Planning Commission Staff Report

Subject: Treasure Hill
Author: Katie Cattan
Date: September 23, 2009
Type of Item: Administrative – Conditional Use Permit

Staff recommends that the Planning Commission review mass, scale, and compatibility of the Treasure Hill Conditional Use Permit (CUP) as analyzed in the staff report and presented by the applicant, and discuss the project as a work session item. A public hearing shall follow the work session during the regular meeting. The public hearing should be continued to November 11, 2009.

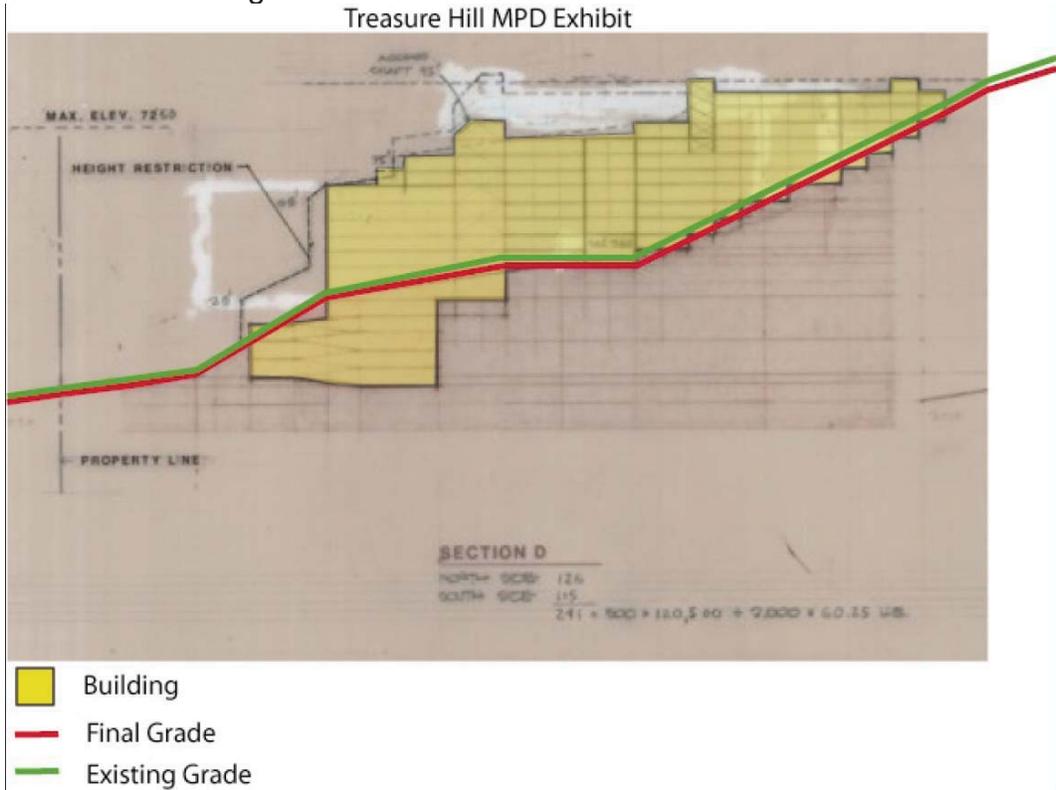
Staff finds that the excess square footage included in the project that is influencing the building massing and bulk. The building mass and bulk is also influencing the orientation of the buildings on the site. The original MPD exhibits were to be utilized as guiding documents. The following is from Exhibit 19 and is an architectural section of one of the buildings on the Creole site.

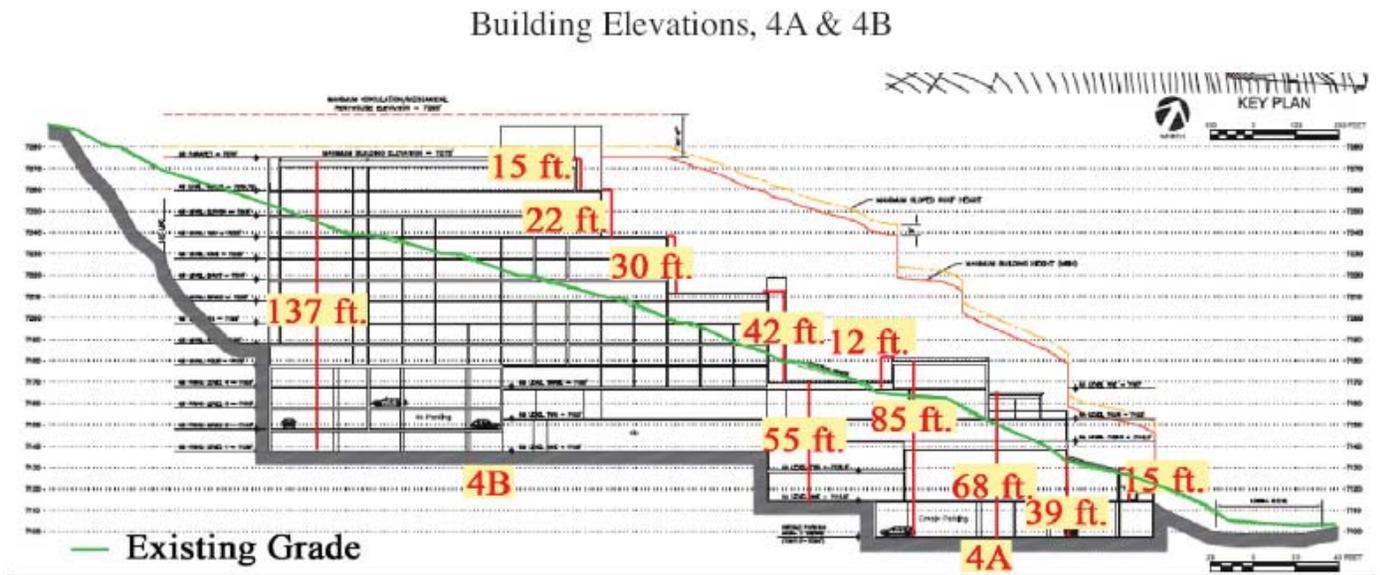
The building steps with the grade on the site and manages to keep final grade (after construction) close to existing grade (pre-construction). The majority of the area shown below grade is for the parking.

The current application places more massing and bulk below the existing grade. Not only is the massing placed below the existing grade, the grade is then altered dramatically creating taller building walls, taller retaining walls, and greater massing. The following is a section through Creole site plan of the project. The green line is existing grade. The red line is the maximum height envelope. By creating a lower final grade, the buildings appear taller and the bulk and massing becomes larger. The pedestrian walking through the project will experience higher building walls due to the change in final grade. Also, the view from other parts of town (Exhibit B) is of building with greater massing due to the change in final grade from existing.

Staff expects grade to be altered on the unique, steep site in order to accommodate the amount of density allowed on this site, exterior circulation, and parking. The extent to which existing grade is being altered is far beyond the anticipated amount within the MPD and is creating greater impacts to mass and scale. The MPD was clear that the height measurement would occur from natural grade and were within height envelopes. By modifying natural grade over 100 feet, the height envelopes do not serve the purpose for which they were created.

Staff also expects that the hotel use will necessitate storage and accessory use. Planning to have accessory space and additional storage under ground is an effective means to mitigating massing and bulk above ground. Staff finds that the current design is very excessive in the amount of accessory space, storage, and circulation which is creating impacts on the overall massing and bulk of the buildings. Within Exhibit A, staff has calculated the common space, circulation, and accessory space as a percentage of each building. The percentage is up to 41% in some buildings creating an inefficient design. Also, as discussed previously, the application exceeds the possible maximum

4. Should the design be revised to become more efficient and comply with the limits of the MPD?

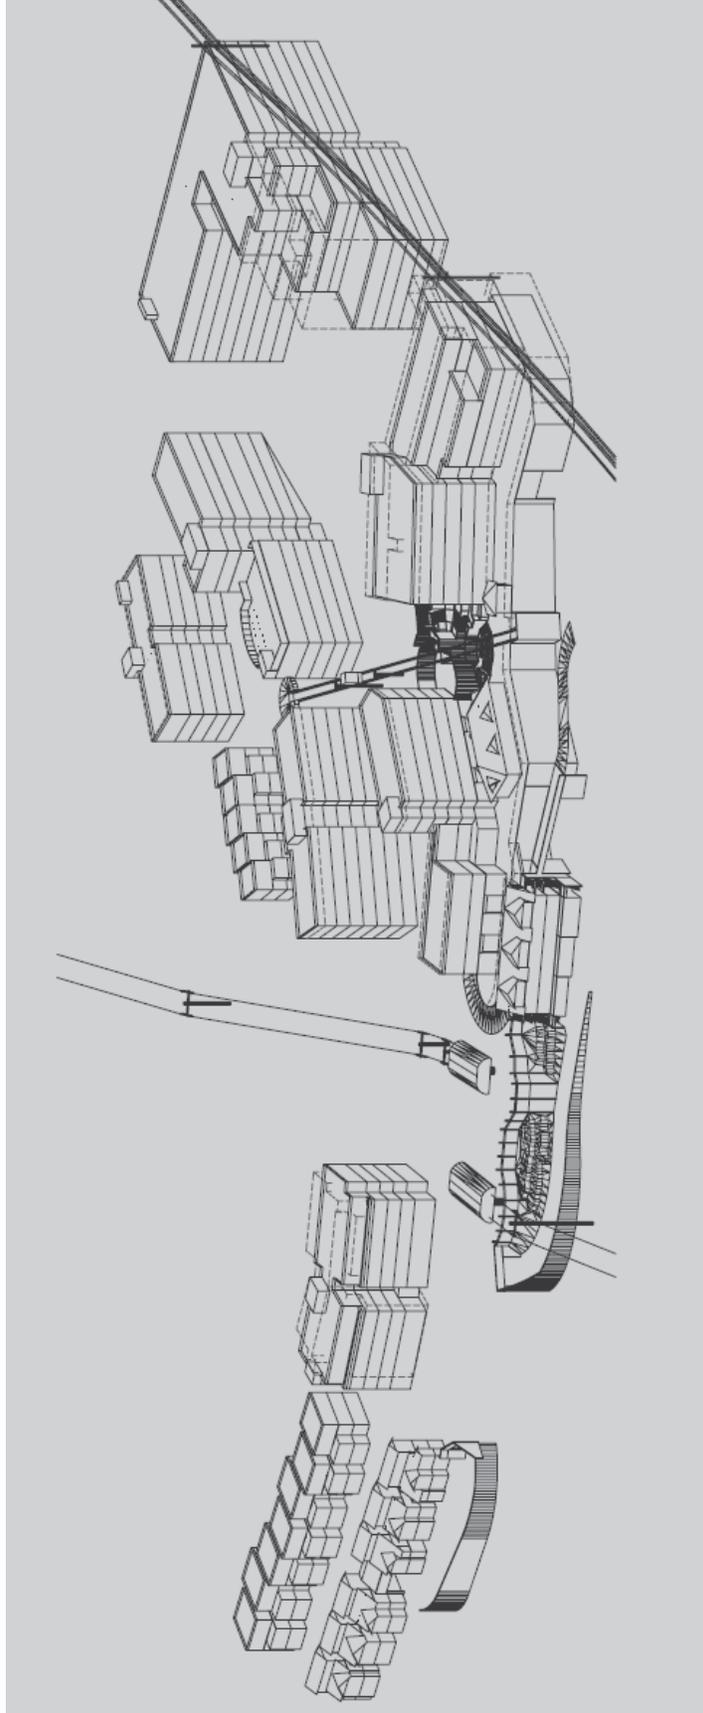
Compatibility with the surrounding structures in mass and scale must be considered within the rights of the Sweeney master plan. The master plan created an area of greater height allowances and density next to a historic neighborhood with low height and medium density. The MPD essentially created a new zone with height envelopes and greater density adjacent to the HR-1 zone, Estate zone, and open-space. The Planning Commission must find compatibility with surrounding structures within the higher density already approved.

Staff acknowledges that it will be difficult to achieve a project massing that is similar to the existing neighborhood context given the previously approved density and volumetrics set forth in the MPD. The Sweeney Master Plan anticipated the difficulty of designing higher density adjacent to the historic district. The following is from the analysis section of the 1985 Master Plan staff report:

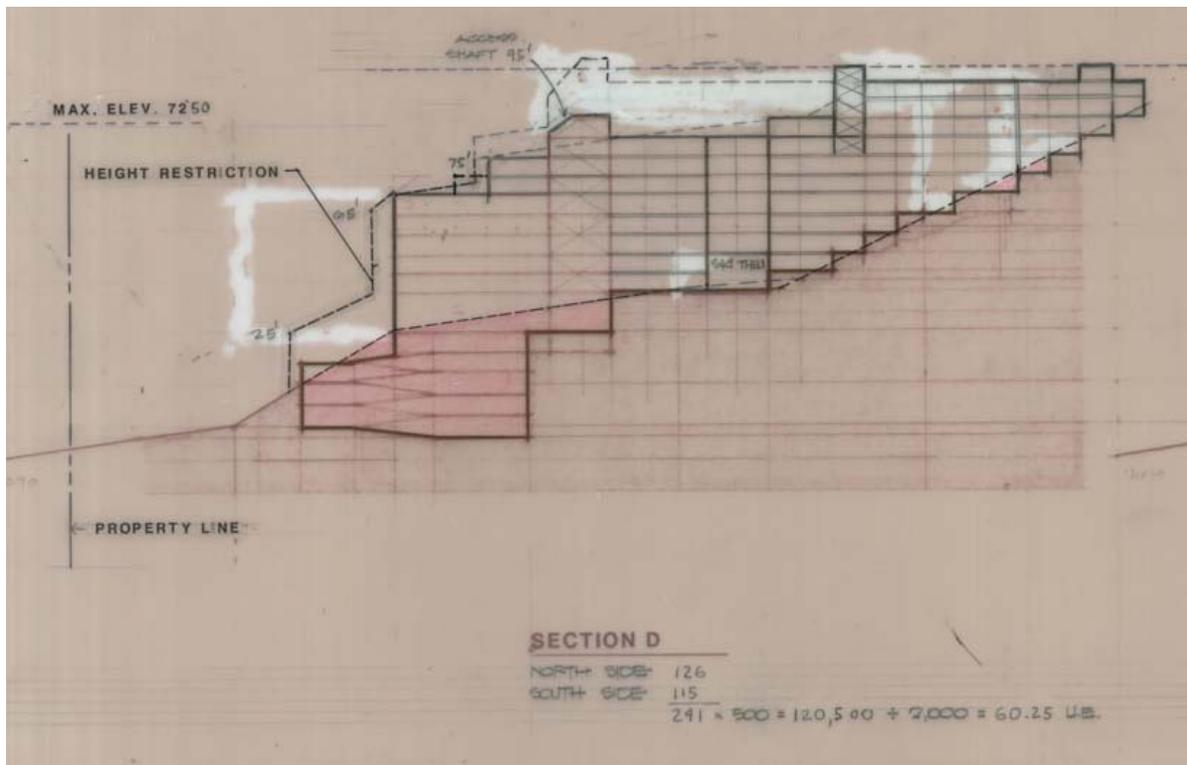
The proposed design requires a very large excavation and re-grading of the entire site. The project is located on the mountain side on steep topography. The impacts to the slope and existing topography are substantial and unmitigated. The project as designed will create a very large hole on the site. The project does not step with the natural topography of the site. As discussed previously, staff finds the project as designed is not in compliance with the concept approved by the City Council during the 1986 Master Plan approval. The exhibits within the master plan showed the building volumes stepping with the existing grade with the exception on the underground garage.

By stepping with the natural grade, there is less excavation. The exhibits within the master plan are guiding documents. The exhibits show minimal impacts on excavation.

8. Are the proposed structures appropriate to the topography of the site?
